# GENERAL S ELECTRIC

#### ATTACHMENT 1

# QUESTIONS ON CONVERSION PLANT EXPANSION

QUESTIONS ON INCINERATOR REPLACEMENT

# FIGURE 3 - DETAILED PROCESS FLOW DIAGRAM

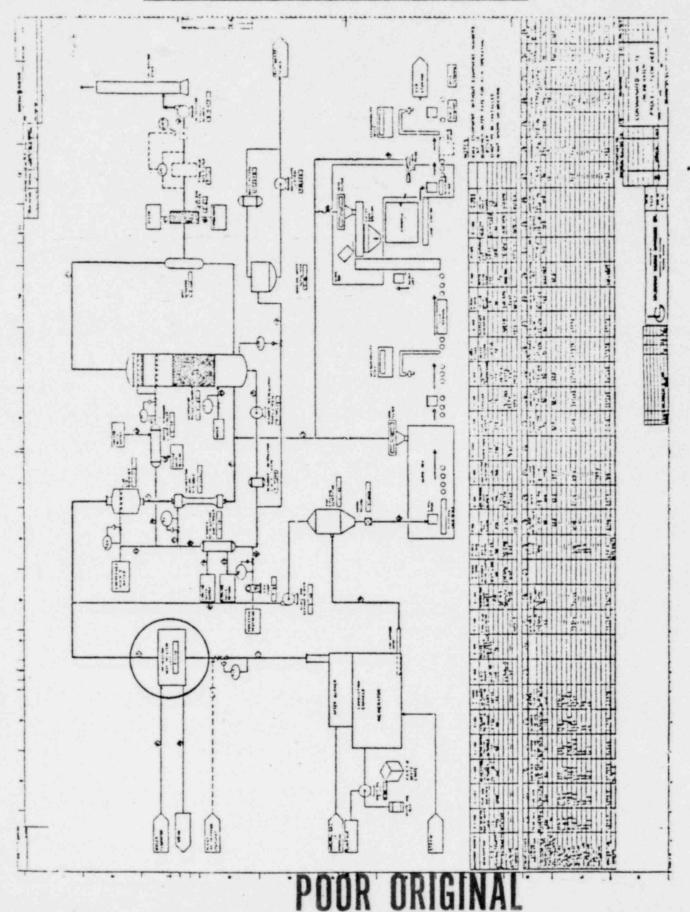
Page 8 and Figure 3 - The process flow diagram shows a heat recovery unit in the offgas stream; however, no mention of this unit is made in the process description on page 8. Please clarify.

Figure 3 - There are no flame sensors or flame control devices for the incinerator or the afterburner indicated on the diagram. What provisions are made to insure that unburned natural gas or propane will not enter the remainder of the system?

The heat recovery unit was originally planned. However, later analysis demonstrated that the unit was not economically feasible. Therefore, this unit is no longer included within the project scope and it has been eliminated from the detailed process flow schematic shown in Figure 3. A new process flow schematic is shown on Page 8 of this attachment. The new detailed conceptual schematic will be provided when it has been completed (within about 4 months).

The total incinerator system will be controlled by a programmable process control device (brand name of Eagle Signal Company). This device senses the temperatures and other primary operating conditions within the incinerator system. The temperatures in the incinerator and afterburner are designed to provide complete burning of natural gas or propane, respectively. If these temperatures vary significantly from the design values, the control device will shut down the system. If the control device fails, the system will be shut down (i.e., it is fail-safe).
